## Volvo Chassis - Model VNR With RH Side Fairing Only - Heat/Splash Shield Loose, Possible DTC P204800 And/Or P204713

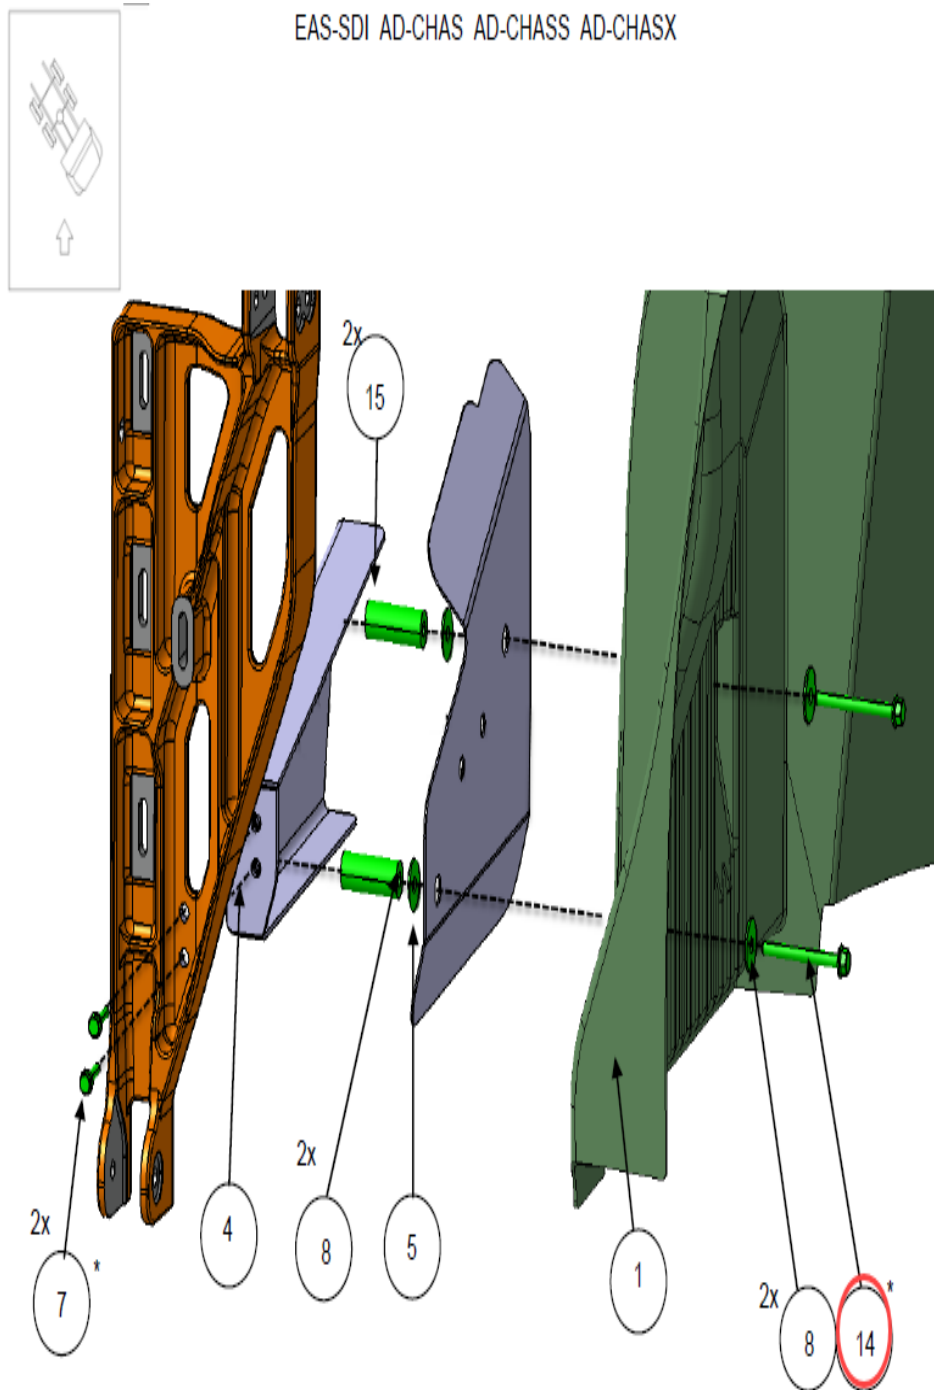
On certain Volvo VNR chassis equipped with a right-hand (passenger) side fairing, there is a possibility that the bolts securing the EATS heat shield/splash shield may become loose. This may lead the shield to rub on the EATS wiring harness, resulting in damage.

Diagnostic Trouble Codes (DTC) P204800 and P204713 may be observed as a result of the harness fatigue due to the loose shield.

1. Remove the 2 bolts (#14 in the image below) securing the heat shield.
2. Apply blue Loctite to the threads of the bolts.

Install the bolts with the addition of a jam nut, part number 000050, to the end of each bolt.

990930, to the end of each bolt.

- The bolts should be torqued to  $12 \pm 2$  Nm ( $9 \pm 1.5$  lbf)

\* TORQUE TO  $12 \pm 2$  N-m
